AGENDA – WORKSHOP OF THE PLANNING & ZONING COMMISSION OF THE CITY OF PEARLAND, TEXAS, TO BE HELD ON JUNE 16, 2008, AT 7:00 P.M., IN THE COUNCIL CHAMBERS, CITY HALL, 3519 LIBERTY DRIVE, PEARLAND, TEXAS.

2. **COUNCIL INPUT AND DISCUSSION:** REGARDING THE PROPOSED TOWNEPLACE RESERVE PLANNED DEVELOPMENT (PD) LOCATED WEST OF CULLEN BOULEVARD, SOUTH OF BROADWAY.
Ms. Lata Krishnarao, Planning Director.

AGENDA OF: June 16, 2008	ITEM NO.: Workshop No. 2
DATE SUBMITTED: June 5, 2008	DEPARTMENT OF ORIGIN: Planning
PREPARED BY: Lata Krishnarao	PRESENTOR: Lata Krishnarao
REVIEWED BY: Nick Finan, ACM	REVIEW DATE: 6/9/2008
SUBJECT: Proposed TownePlace Reserve Planned Development (PD) Located West of Cullen Boulevard, South of Broadway.	
EXHIBITS: Proposed PD Document.	
EXPENDITURE REQUIRED: AMOUNT AVAILABLE: ACCOUNT NO.:	AMOUNT BUDGETED: PROJECT NO.:
ADDITIONAL APPROPRIATION REQUIRED: ACCOUNT NO.: PROJECT NO.:	
To be completed by Department: <input type="checkbox"/> Finance <input type="checkbox"/> Legal <input type="checkbox"/> Ordinance <input type="checkbox"/> Resolution

The Planned Development Zoning District (PD) Document for the Planned
Development District
TownePlace Reserve LP

TOWNE PLACE RESERVE
 AFFORDABLE SENIOR HOUSING P.U.D. PEARLAND, TEXAS

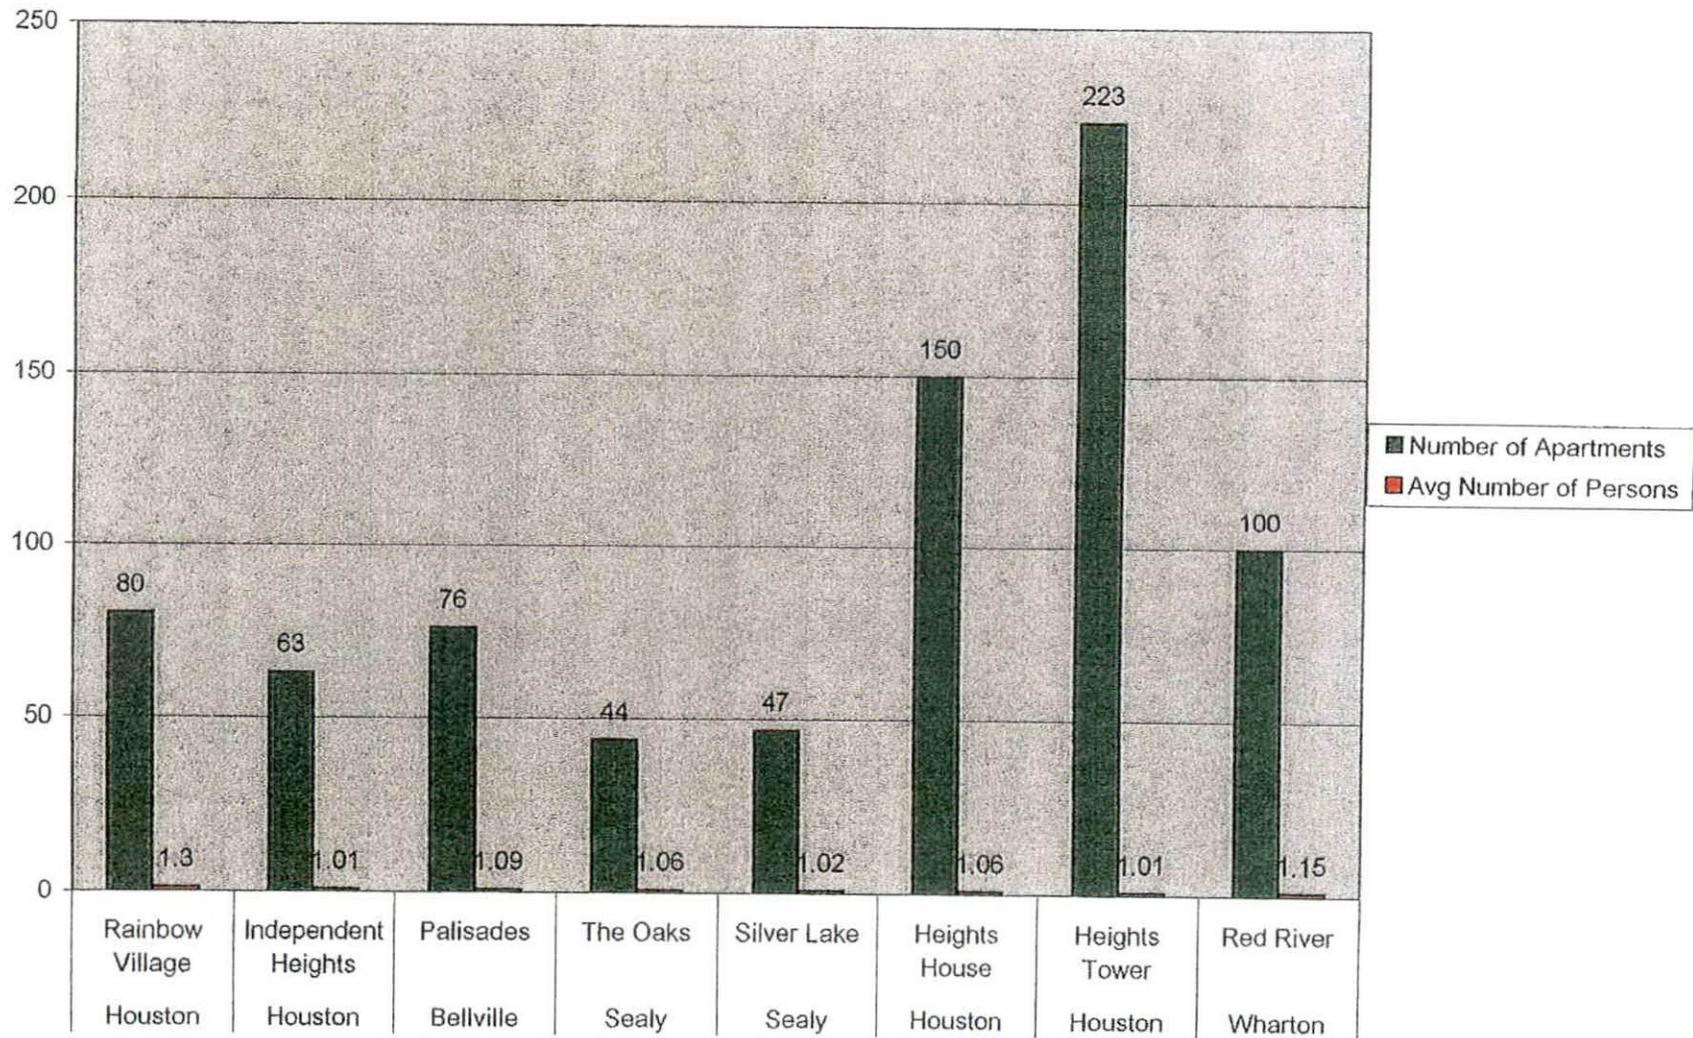
Council and P& Z had requested the applicant to provide amenities and open space for the residents. The detention basin will be provided off-site and that area has been utilized to provide amenities including trails, seating areas, game courts, gardens, etc. These amenities are shown in the site plan attached to the PD document. Staff recommend that details such as material and width of trails, etc. be clarified.

Response: The PD has been modified to state that 124,000 square feet (2.8 acres) of open space is provided. It is not clear how this area has been calculated. The UDC requires a minimum dimension of 80' for any common open space. Therefore, only the courtyard and the area south of the buildings would meet the requirements.

The site plan submitted shows amenities that will be included.
